Dear editor/reviewer,

Authors response to RC1, reviewer Carl Legleiter

Author response to RC2, Doug Thompson.

8.5 cms dv^2

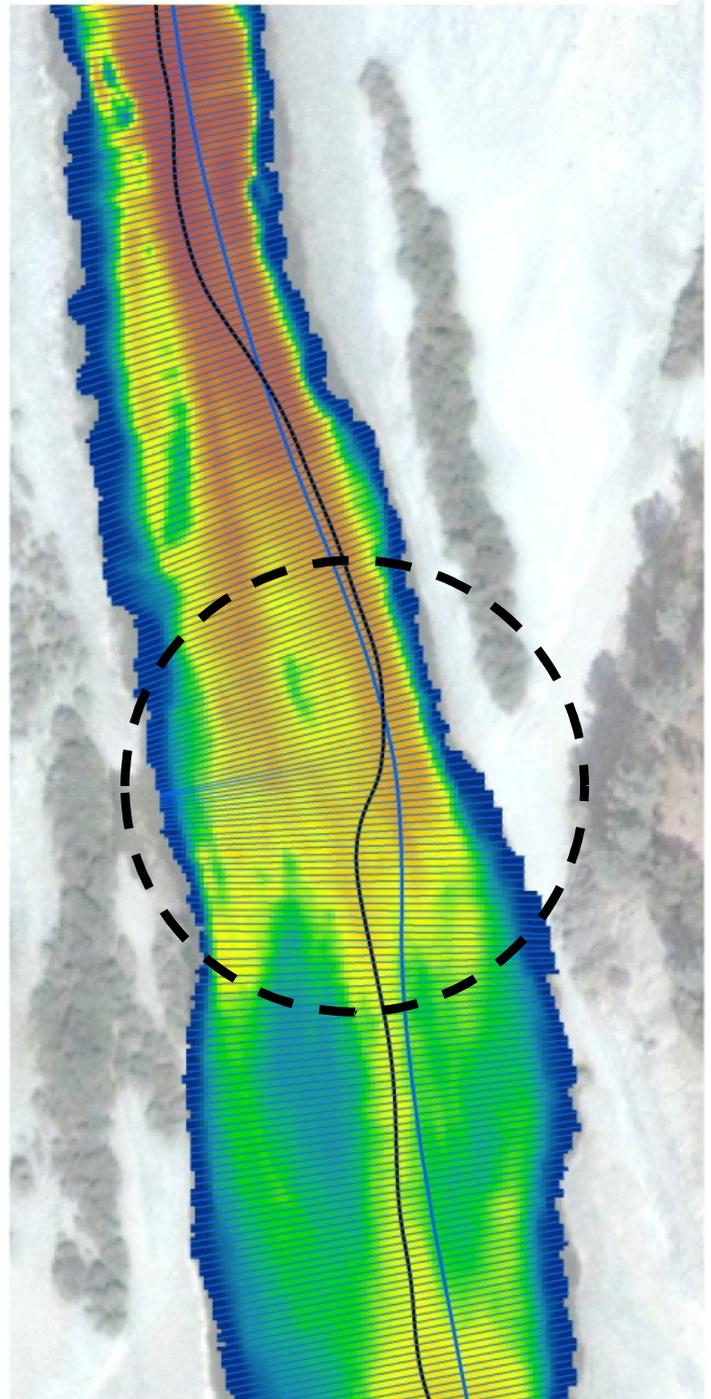
As stated in the text the thalweg is too tortuous to have cross sections that are orthogonal to the flow. To illustrate this we created a figure some of our preliminary work (Figure 1). Figure 1 shows the traditionally defined thalweg and flow dependent sample pathways used in this study with 5m spaced cross sections clipped to the 8.5 cms flow. Visual inspection of this section of the river reveals that the thalweg in many places changes direction in otherwise straight sections of river flow when compared to the momentum based sample pathway. For example the momentum grid shows multiple downstream oriented bands where the thalweg moves left and right. As can be seen the cross sections generated using the thalweg would cause significant overlaps from the tortuous path in areas where flow is otherwise straight (Figure 1b). This is just one example of why the thalweg is not appropriate at low flow, but we found this to be prevalent throughout the study reach.
